**CITY OF WINTER PARK
PLANNING AND ZONING BOARD**

**Staff Report
March 6, 2018**

SPR 18-03 REQUEST OF WINTER PARK DESIGN FOR APPROVAL TO CONSTRUCT A NEW 5,758 SQUARE FOOT SINGLE-FAMILY HOME LOCATED AT 1234 LAKEVIEW DRIVE ON LAKE VIRGINIA, ZONED R-1AAA.

REQUEST OF VERAX INVESTMENTS, LLC FOR: CONDITIONAL USE APPROVAL TO CONSTRUCT A TWO STORY, 20,000 SQUARE FOOT MEDICAL AND GENERAL OFFICE BUILDING ON THE PROPERTY AT 1111 WEST FAIRBANKS AVENUE, ZONED C-3.

© 2018 KTH Architects, Inc.

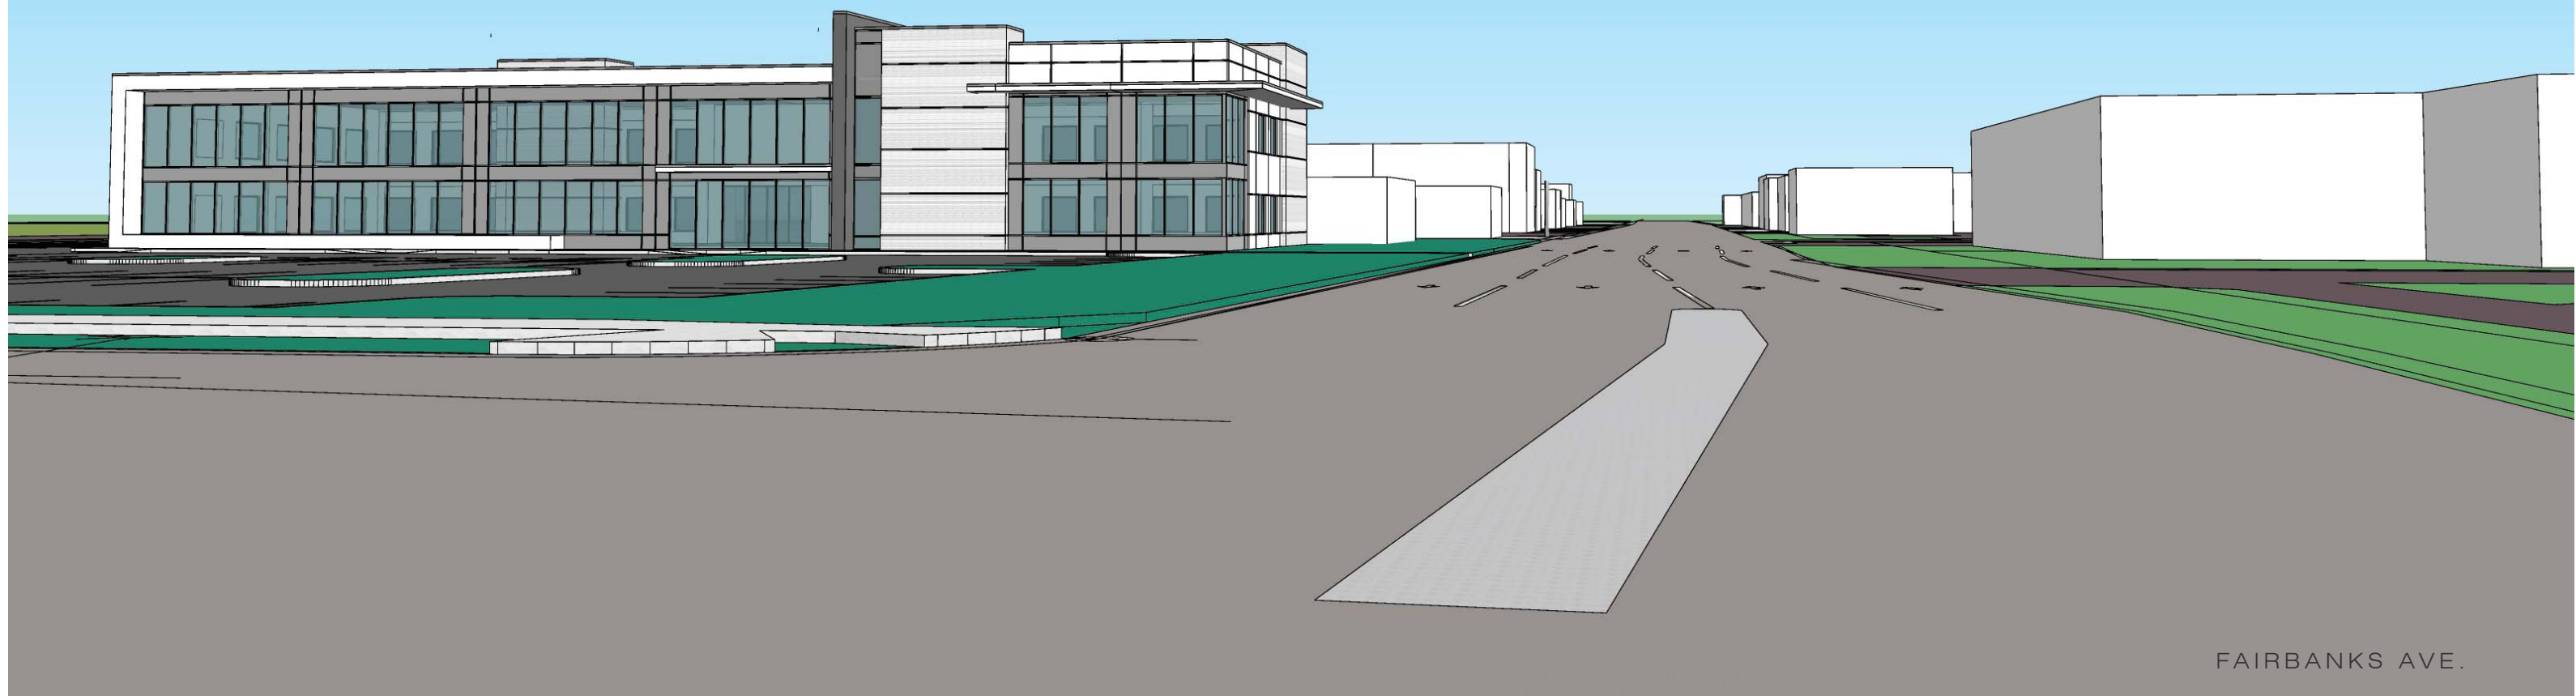
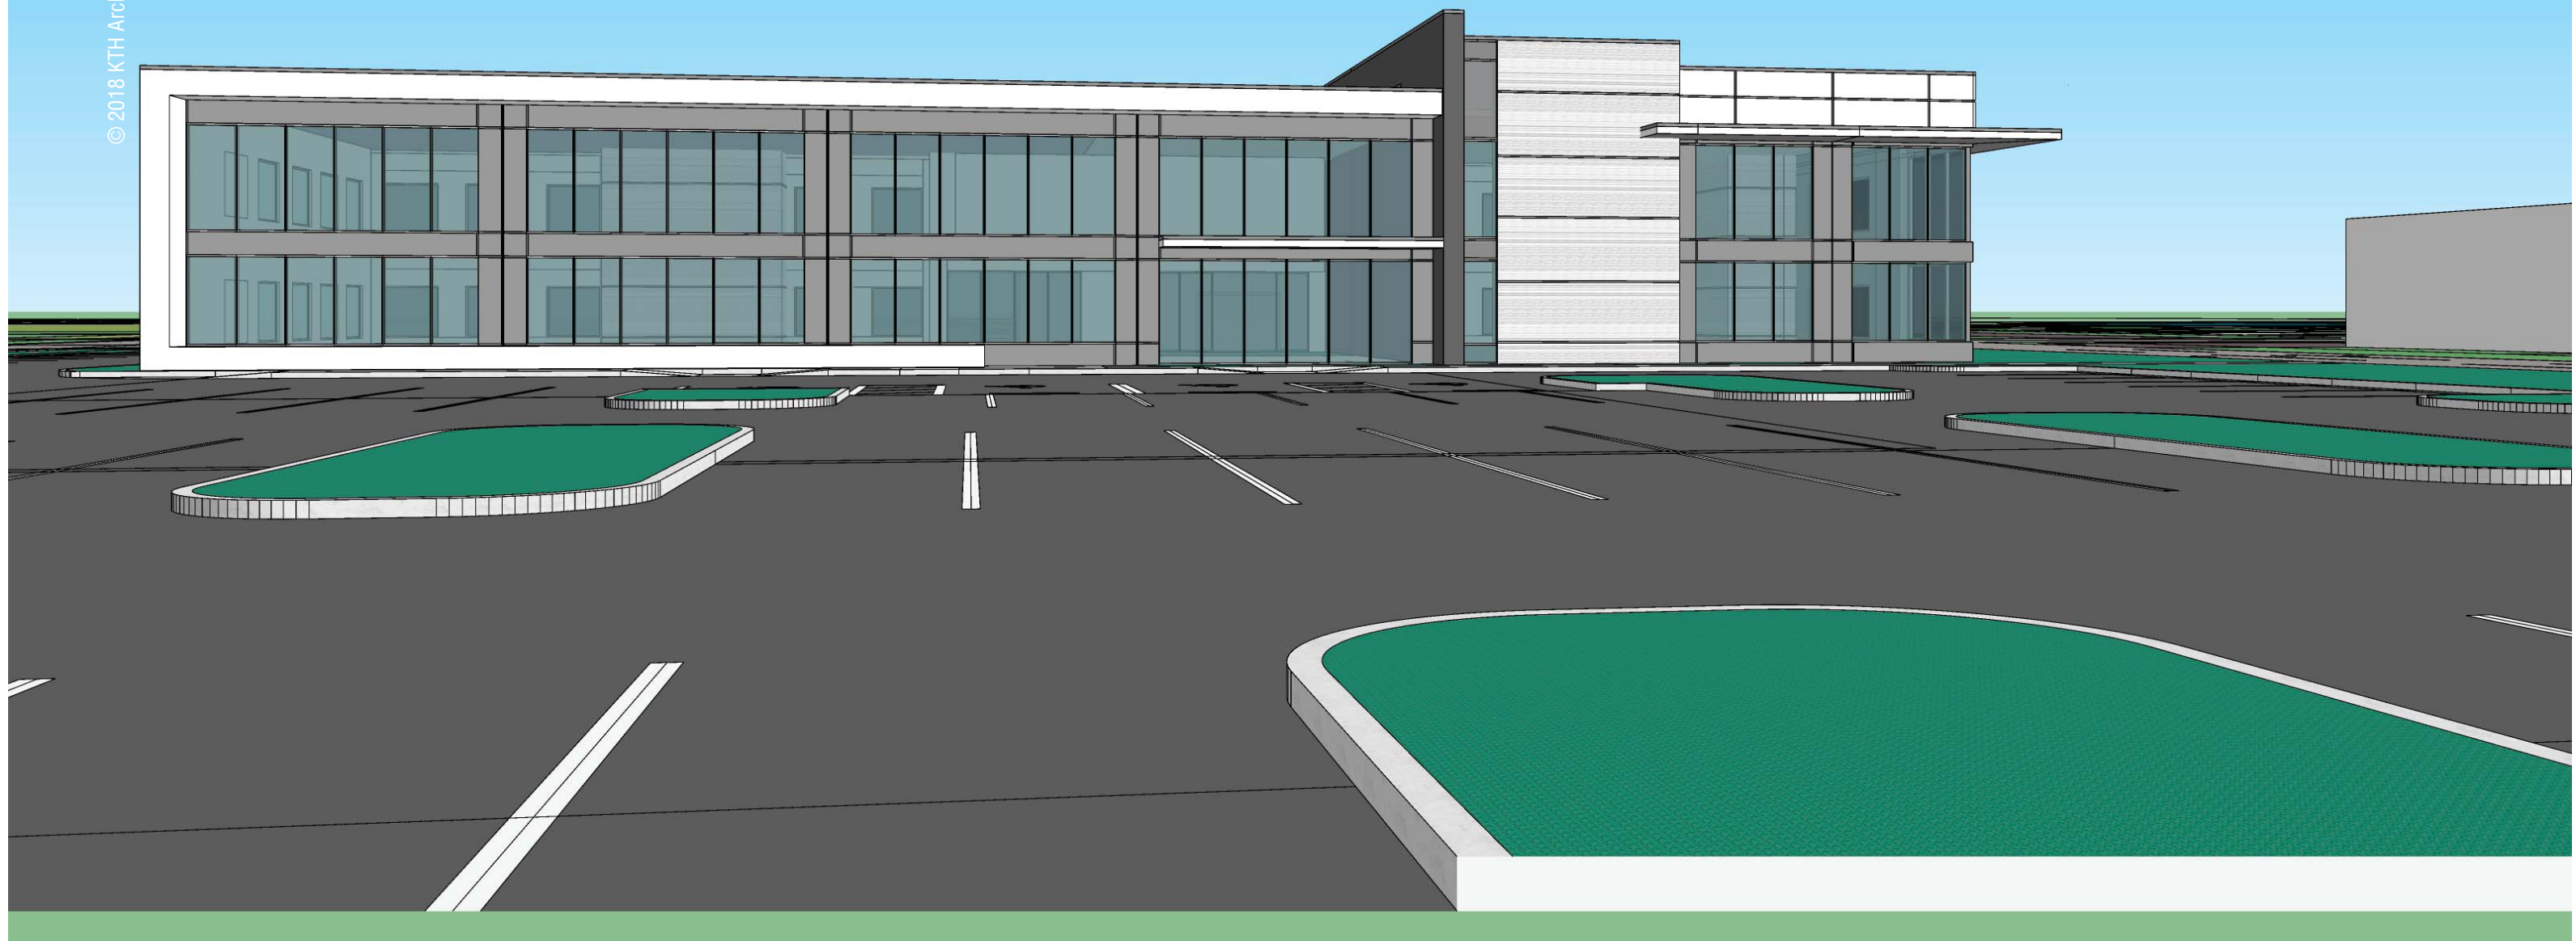
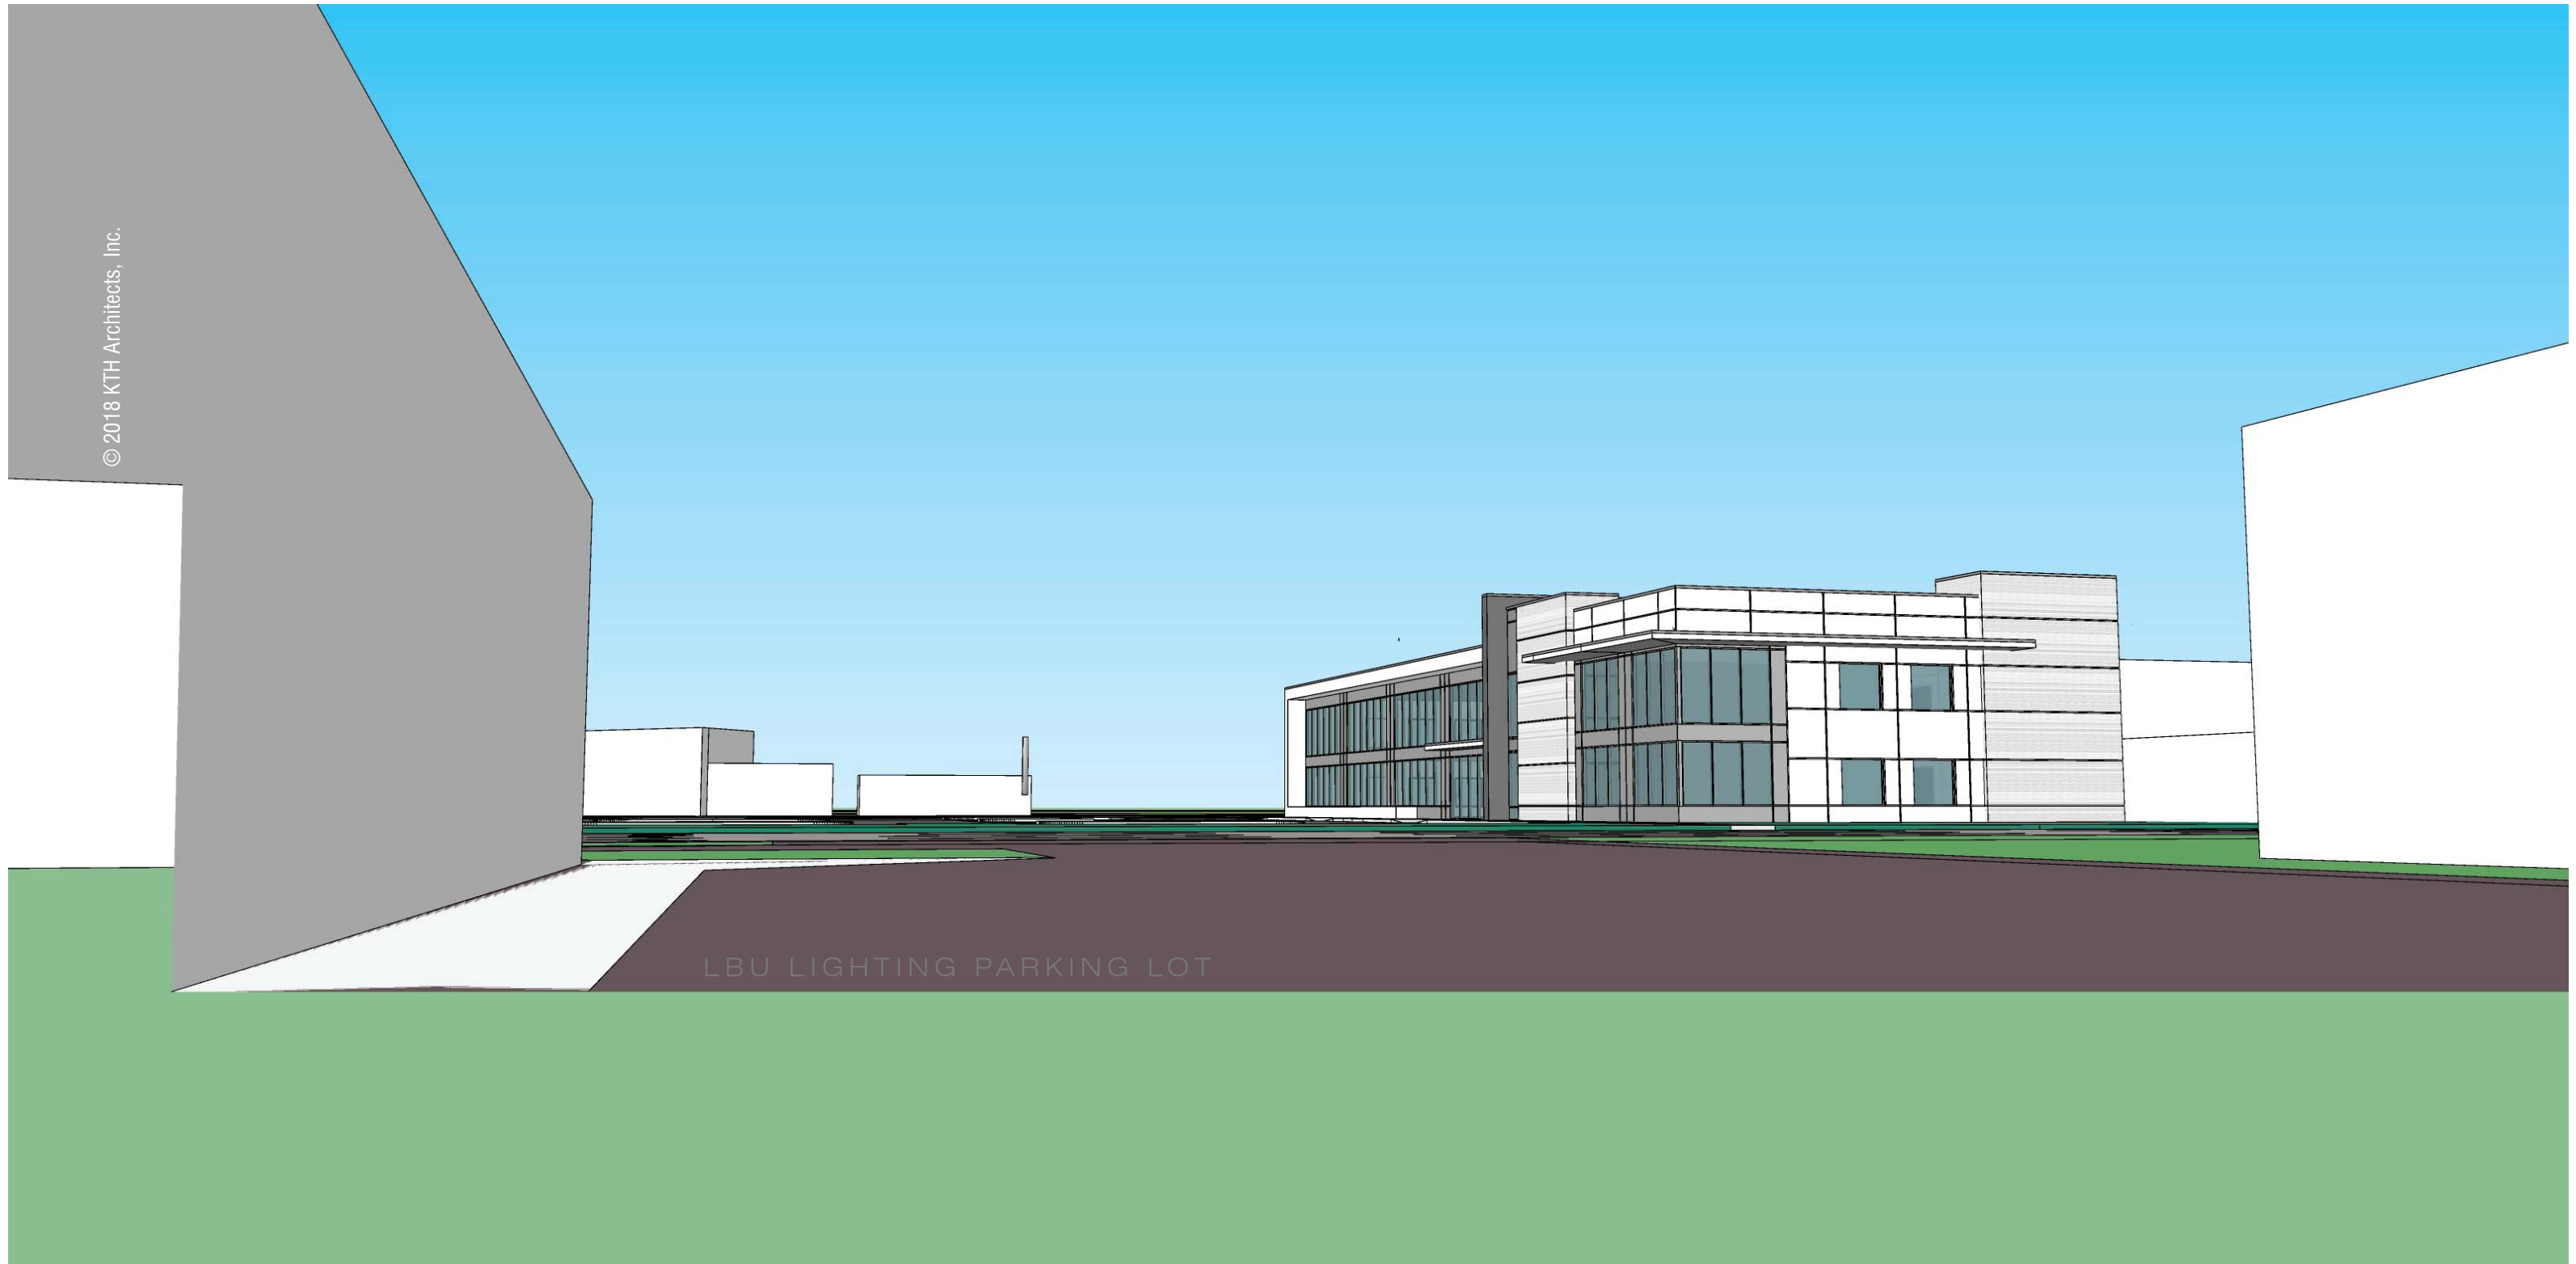
Architectural Image: Perspective elevations are included in the agenda materials depicting the look of the proposed office building. It is a contemporary architectural style. Again, as with some previous applications (Rollins Facility Bldg. & Sprouts) the staff will condition this request on a return to P&Z/City Commission with revised architectural images for some potential improvements in design or material selection.

- 1. That the final architectural elevations and materials of the proposed office building, be revised to a traditional architectural style other than a contemporary or postmodern style and that such architectural elevations and materials be subsequently approved by the P&Z Board and City Commission after input and dialogue with the city architect.**
